# Access Compliance Report

## Public Rights-of-Way

### (Pedestrian Signals)

Intersection ID: N/A	Main Street:	Cross Street: N/A	Location: N/A
ADA ID: 4FE02295BE07	Signal Type: One Push Button-Non APS	Overall Compliance: No	Severity Score: BTN 1: N/A BTN 2: N/A No BTN: N/A
Codes/Mitigation Info/Possible Solution		Field Measurements/Component Compliance

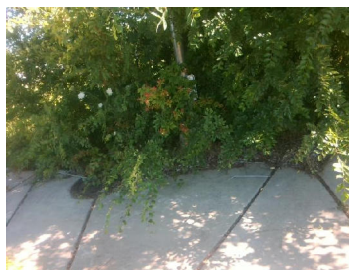
Surveyor Notes: BTN IN BUSH. LOW VEG IN CLEAR SPACE

PROW/ADA: TMUTCD 4e.08, R406.2

Possible Solutions: Replace Signal Push Button With APS Button on New Post. Remove & Relocate Sign.
